Product Change Notification / LIAL-10HDQI000

CCB 3104.005 Final Notice: Qualification of MPHL as a new final test site for selected ATMEGA48xx, ATMEGA88xx and ATMEGA168xx device families available in 32L TQFP (7x7x1mm) package.

CCB 3104.005
Pre and Post Change Summary
PCN#: LIAL-10HDQI000

Tape and Reel - Carrier Tape

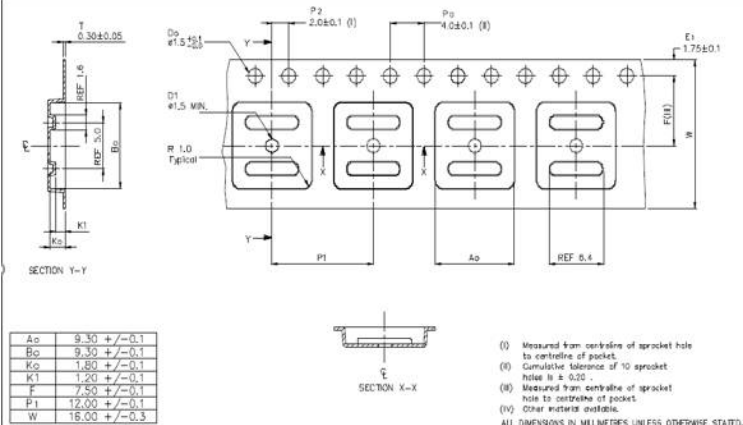
W	P	A0	B0	K0	K1
16.00 (+/- 0.30)	12.00 (+/- 0.10)	9.30 (+/- 0.10)	9.30 (+/- 0.10)	1.80 (+/- 0.10)	1.20 (+/- 0.10)

Thickness	Color
0.30 (+/- 0.05)	Black

Tape and Reel – Plastic Reel

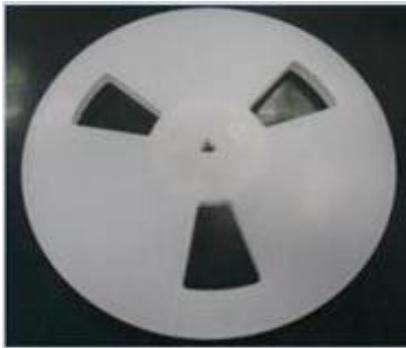
Width	Outer Diameter	Inner Diameter
16	330.2 (+/- 2.0)	100

Color: White
D: 13"
Hub: 4"
W1: 17.5 mm
W2: 21.5 mm
